**PRELIMINARY DRAINAGE REPORT
FOR
URBAN LANDING
PRELIMINARY PLAN**

**CCES
RESPONSES**

Job No. 1308.01
PCD File No. PUDSP243

URBAN LANDING
PRELIMINARY PLAN
PRELIMINARY DRAINAGE REPORT
DEVELOPED DRAINAGE MAP

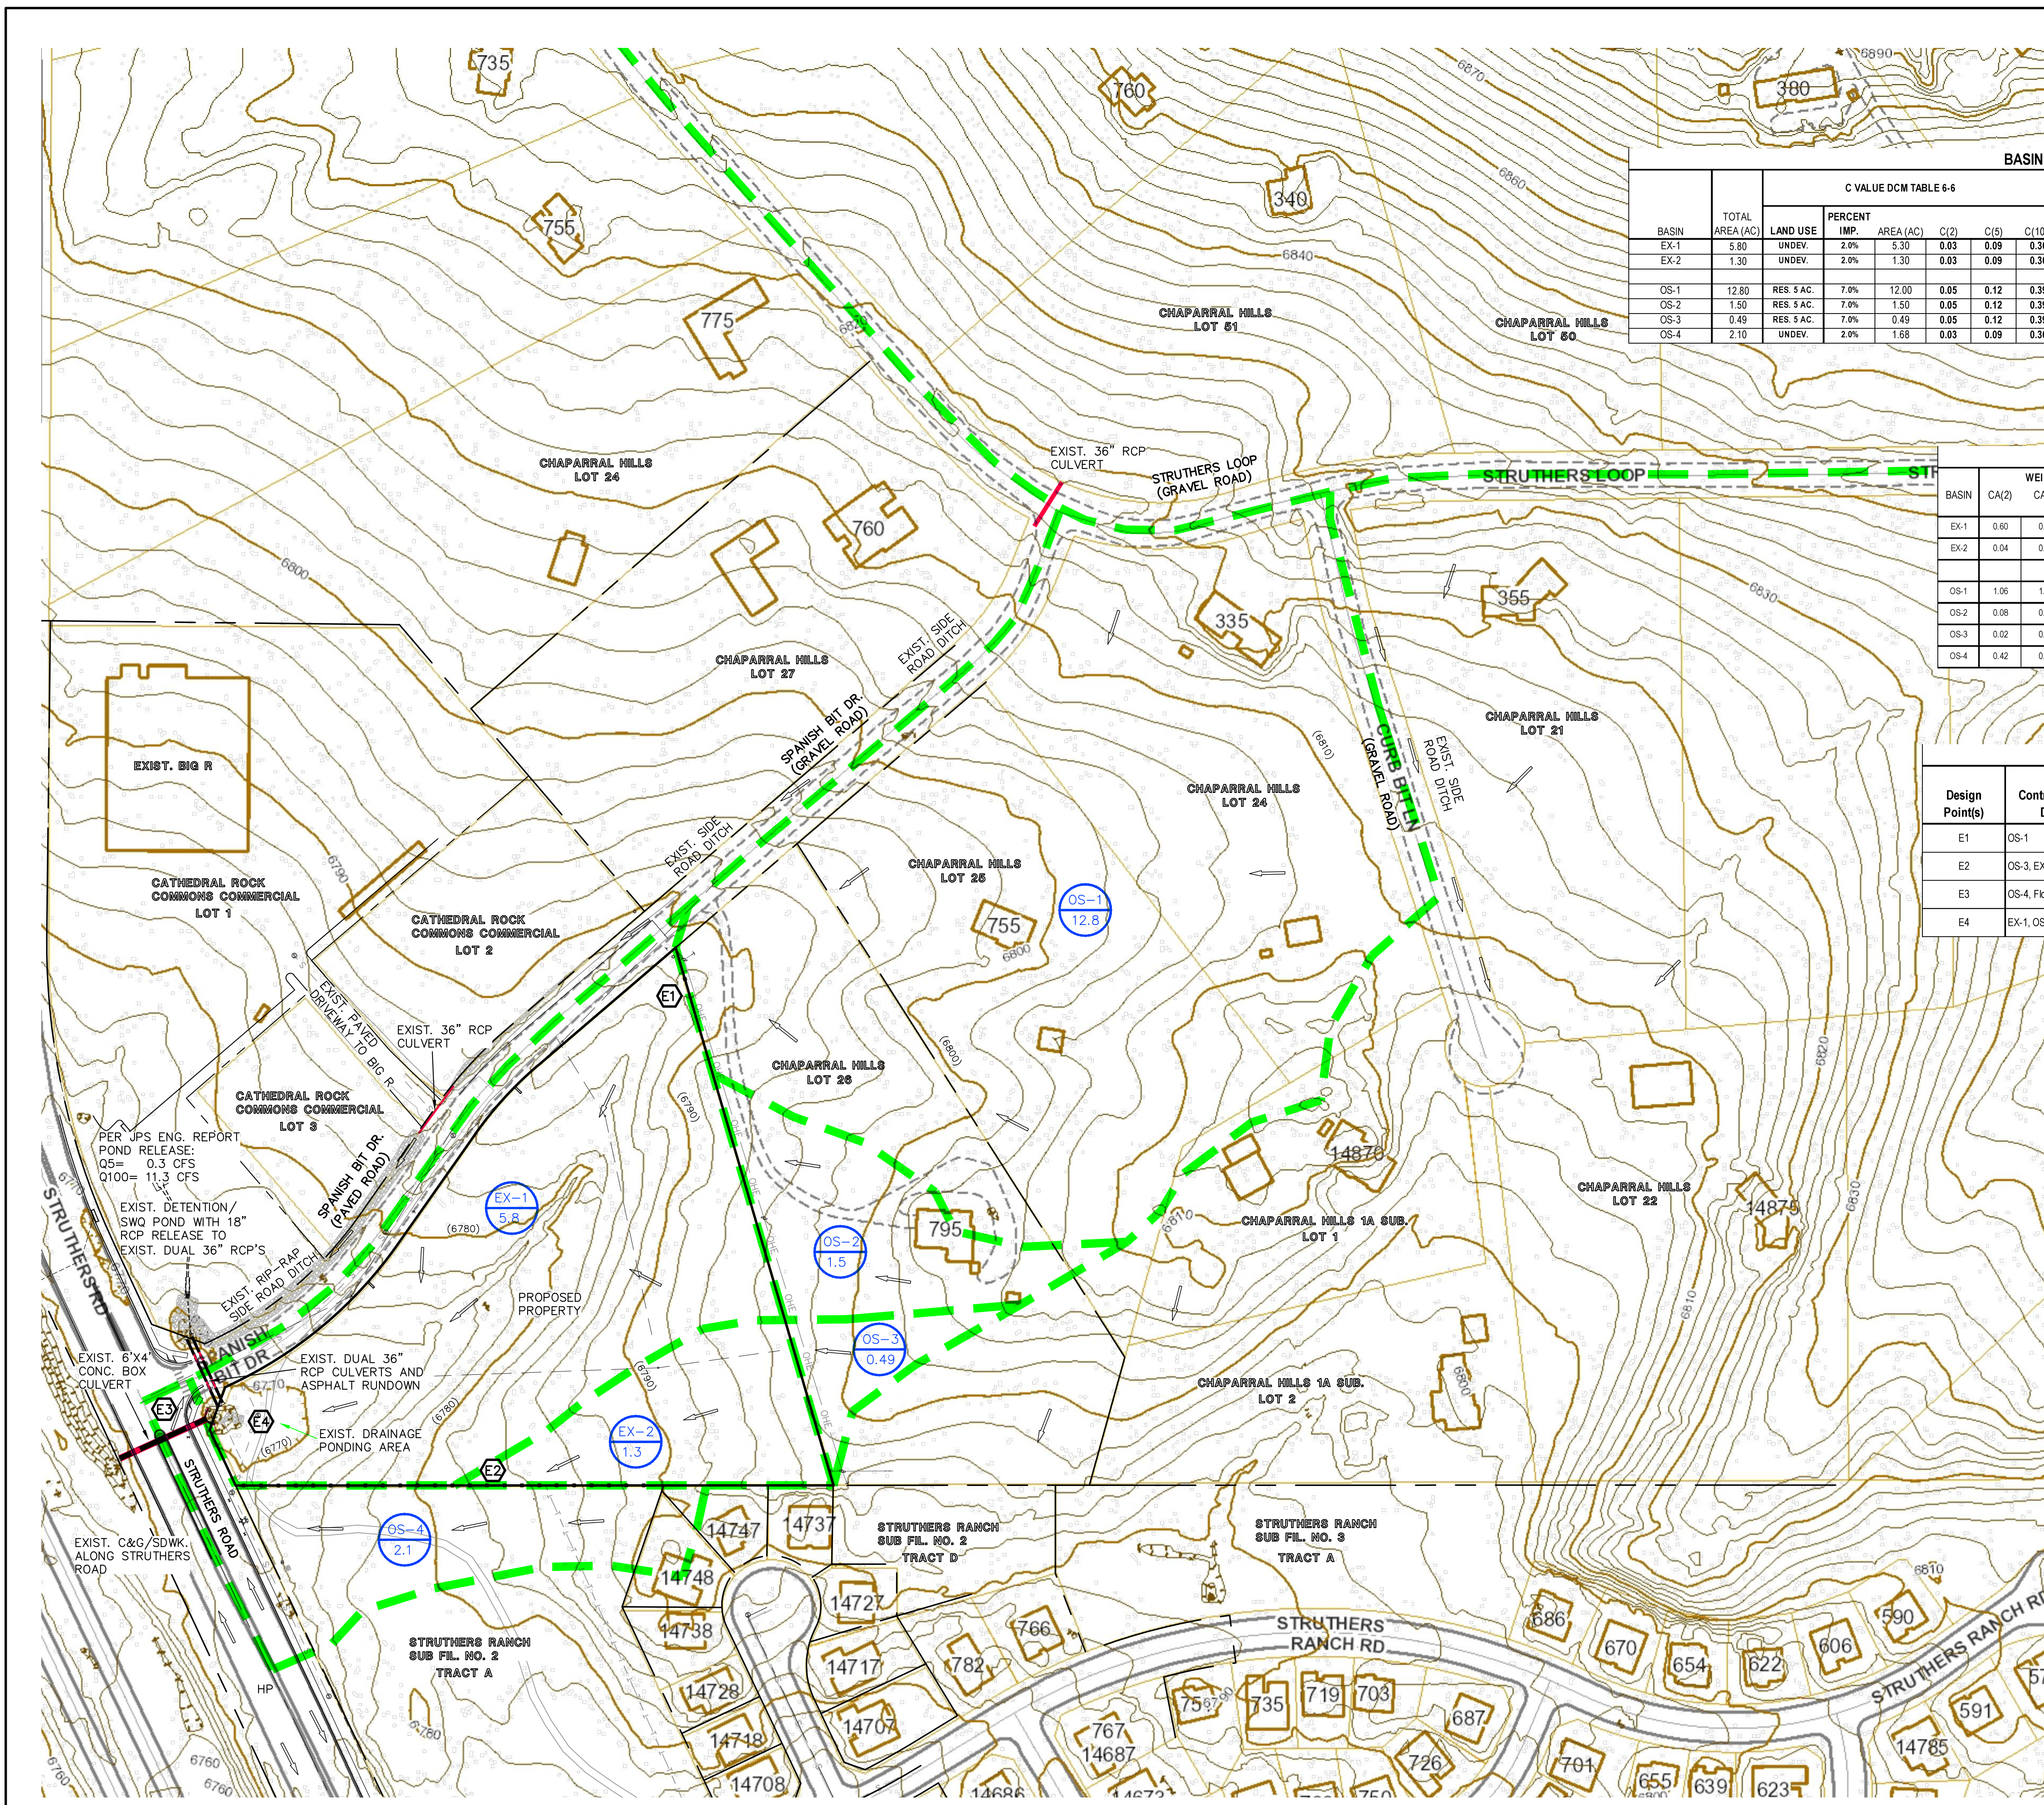
Review C1: The rip-rap and trickle channel for erosion and water quality protection. Revise the design accordingly.

SEE REVISED DESIGN
